LEVEL 1 PLAN
1:500 @ A4

LEVEL 2 PLAN
1:500 @ A4

SECTION CC
1:500 @ A4

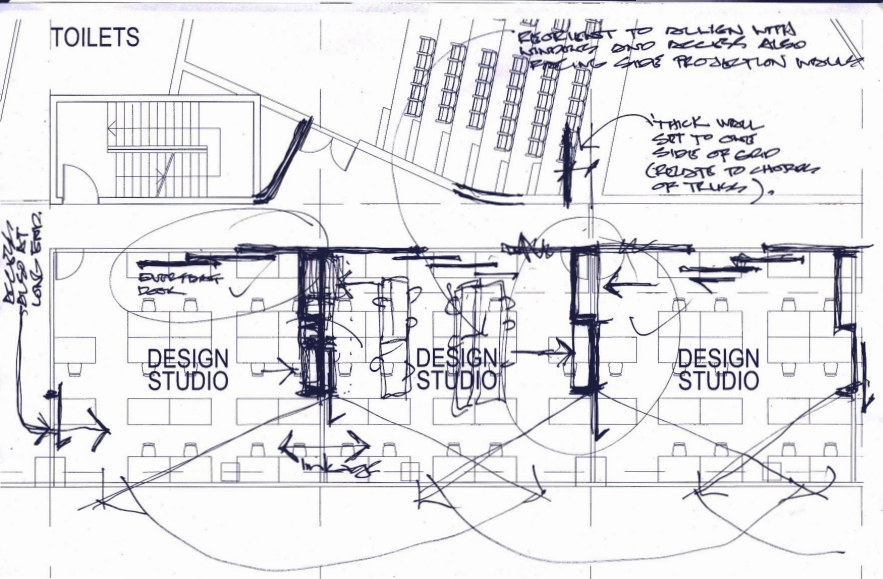
NEEDS TO ALIGN WITH
WINDOWS AND RECES ALSO
FACING SIDE PROJECTION WALL

THICK WALL
SET TO ONE
SIDE OF GRID
(RELATE TO CHORDS
OF TRUSS),

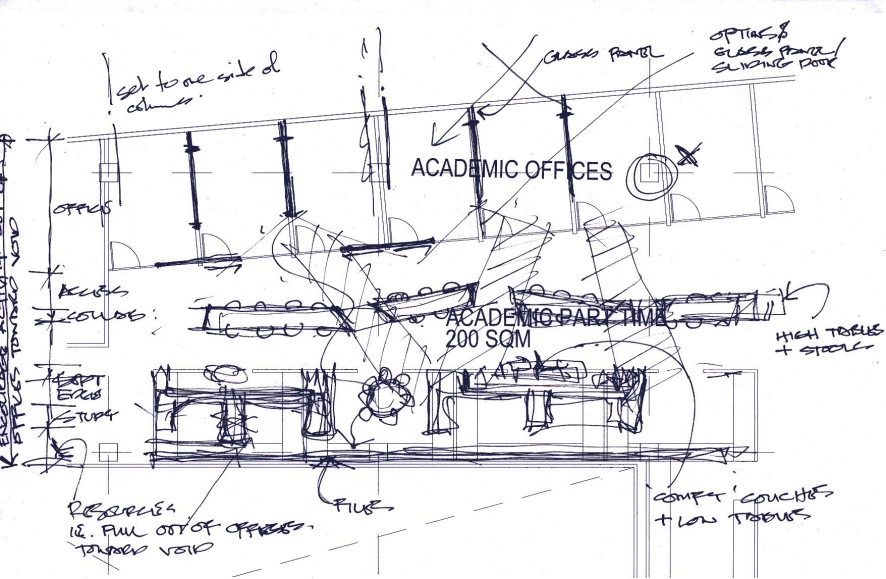
ENCLOSURE ALL PLACES TOWARD VOID

Set to one side of column.

OPTIONAL GLASS PARTIAL SLIDING DOOR

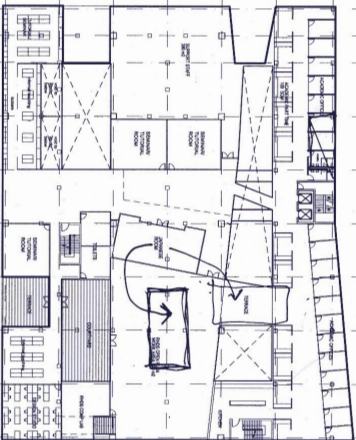
RECEIVABLES
i.e. FULL OFFICE OFFICES
TOWARD VOID

LEVEL 4 PLAN
1:300 @ A4

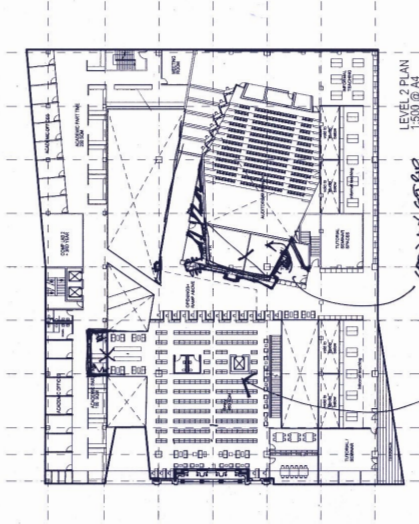
Leftmost floor is
whole 'reception area'
and it's extremely
characteristic

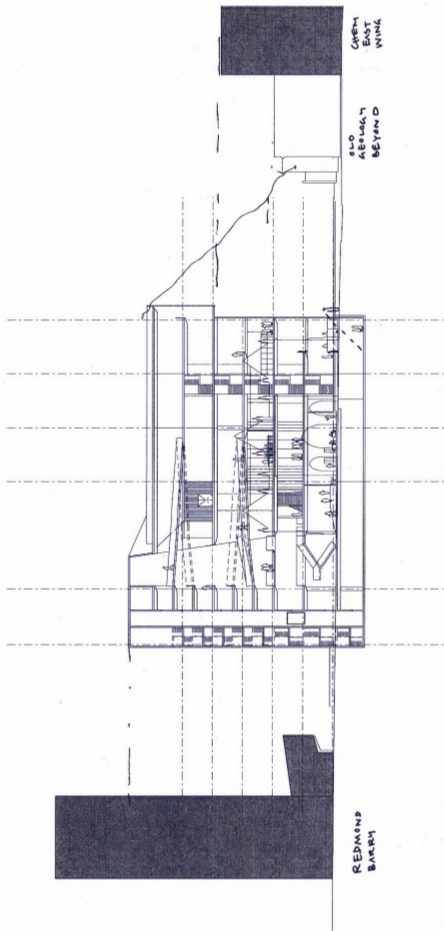
CHANGING OFFICE
OF 1 OFFICIAL SPACE
NEED MORE CHANGING SPACE
FOR: UNIFORMS (YOUNG 1-3)
AND RECEPTION WORKING

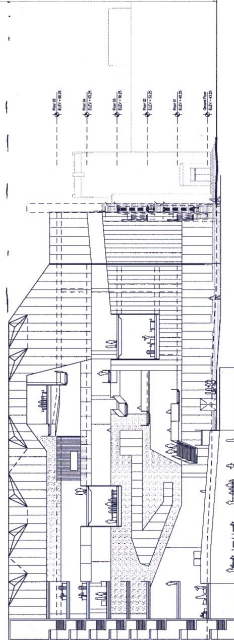
possibly reverse
angle of atrium wall
adjacent to open out
to views of sky.
